Foretravel, inc.

Reference: NHTSA Safety Recall # **R05V-249**

Foretravel Service Bulletin

Subject: NHTSA Safety Recall # RO5V-249

Illustration #1

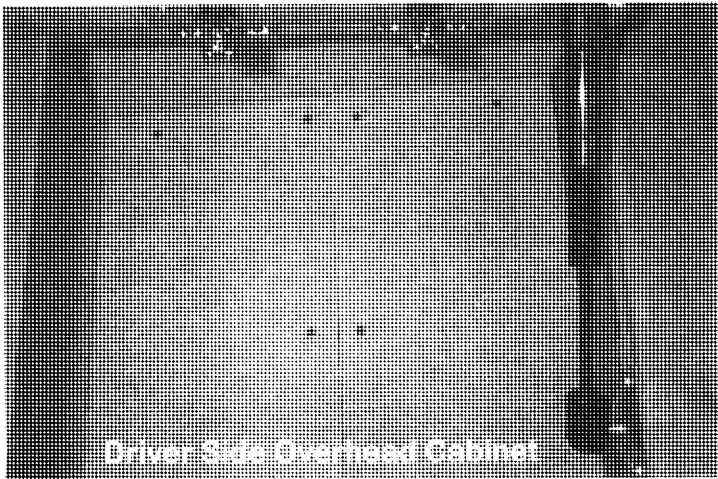
1. Remove dash panel at entry door area for access to automotive breaker panel.
2. Disconnect power at circuit breaker # 15.
3. Remove panels in the overhead cabinets to the right and left of television for access to the wiper motor cover boxes. **See illustration 1 and 2.**

Illustration #3

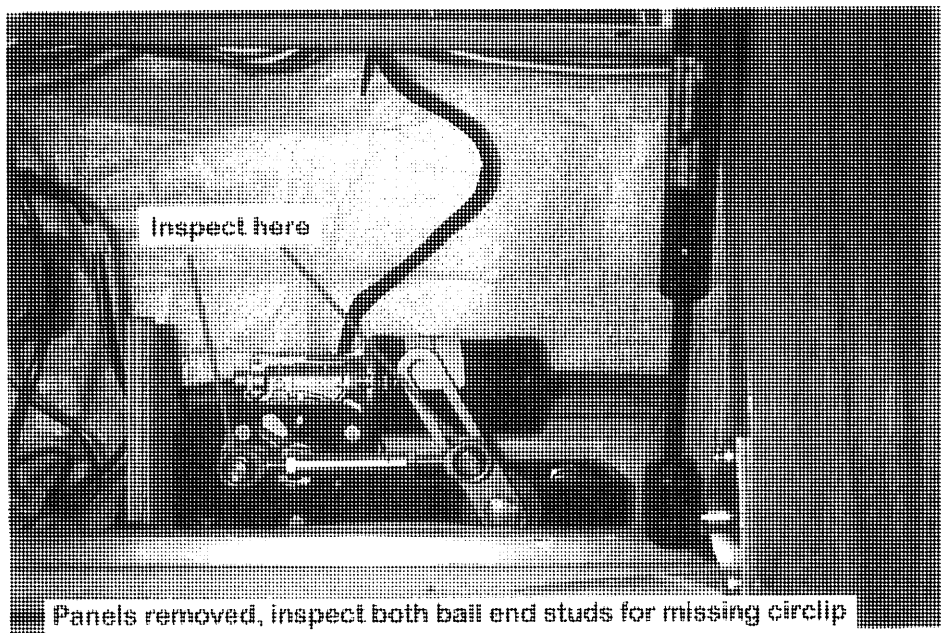
4. Remove covers for wiper motors.
5. With covers removed inspect ball joints for circlip (snap ring). **See illustration 3.**
6. If circlips are present there will be no need to replace existing circlips.

7. The units that have no circlips present, installation of supplied clips will be necessary. Note: In some cases you may have to press ball joint further onto shaft to access groove to install circlips.

Illustration #4

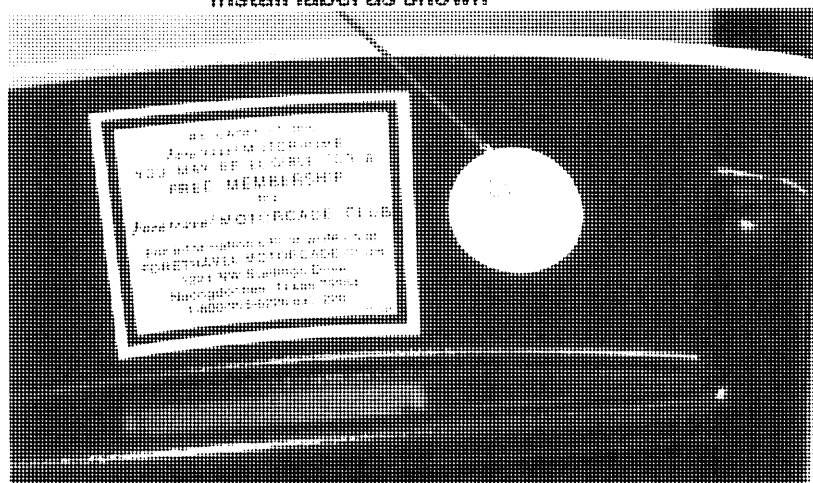
8. After installation of circlips is complete, test operation of wipers and reassemble covers and panels.
9. Fill out supplied label and install in center console door along side of Foretravel Motorcade label. **See illustration 4.**

Install label as shown
